AMENDMENTS TO THE DRAWINGS

Attached hereto are two (2) sheets of corrected formal drawings that comply with the provisions of 37 C.F.R. § 1.84. The corrected formal drawings incorporate the following drawing changes:

FIG. 22  
PRIOR ART

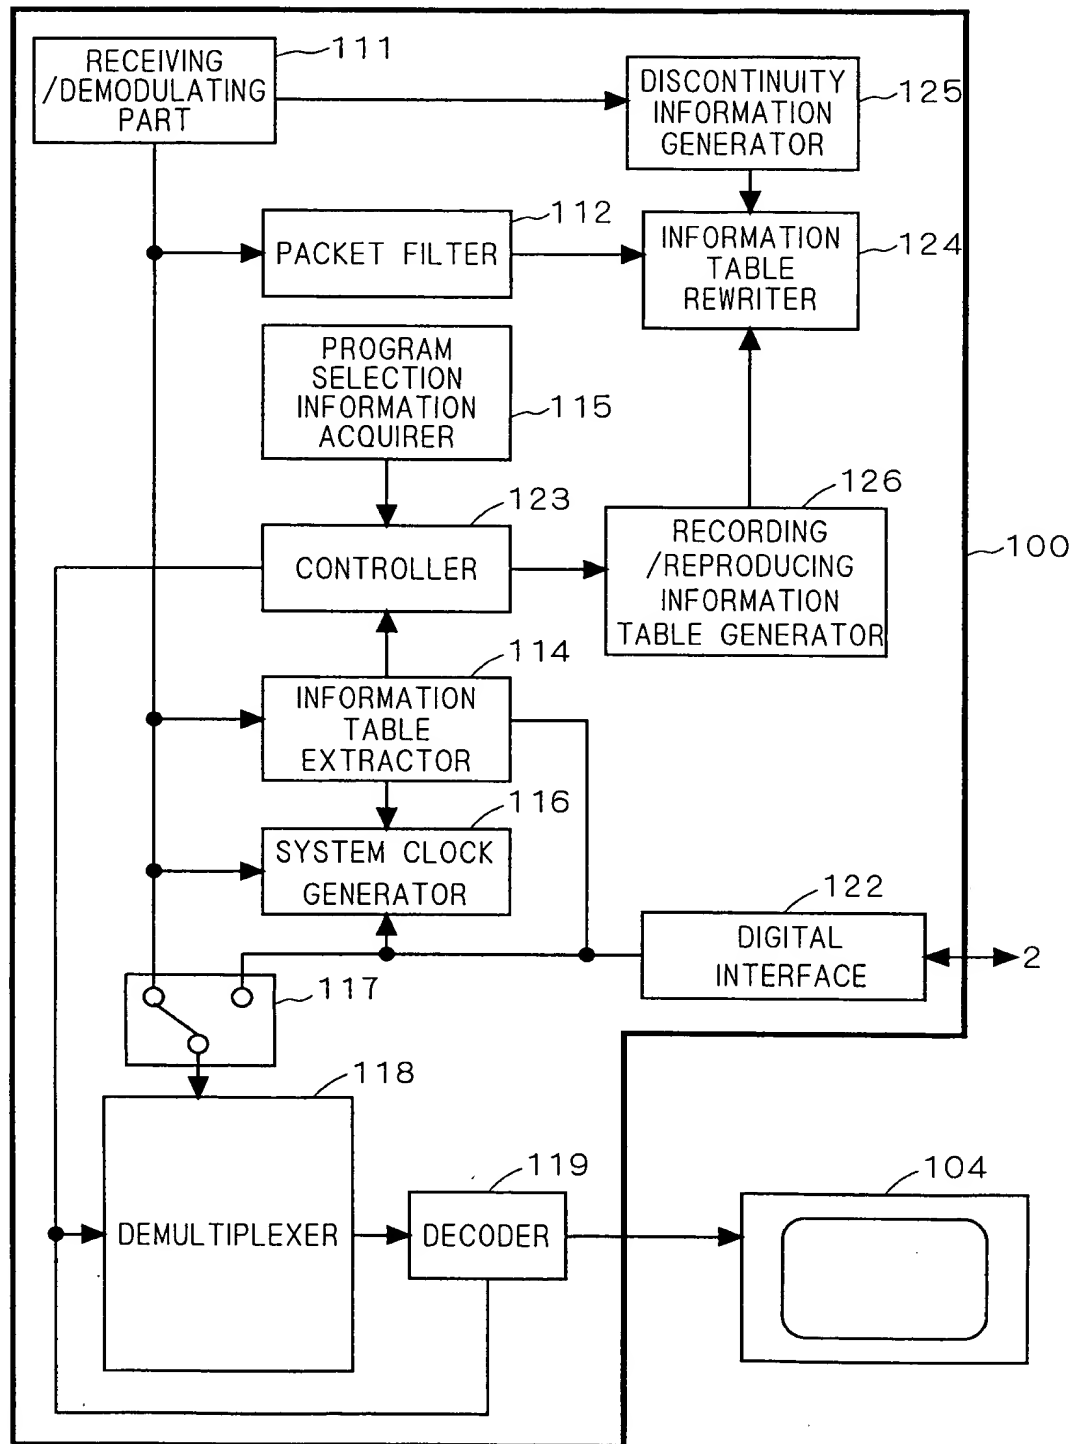
In compliance of the Examiner's objection, Figs. 22 and 23 have been labeled with a legend "Prior Art" indicating the conventional status of the technology shown therein. In addition, a typographical error has been corrected in element 122. Specifically, "digitral interface" has been corrected as "digital interface". Furthermore, switch element 117 has been appropriately labeled in Fig. 22. There are no other changes to these drawings.
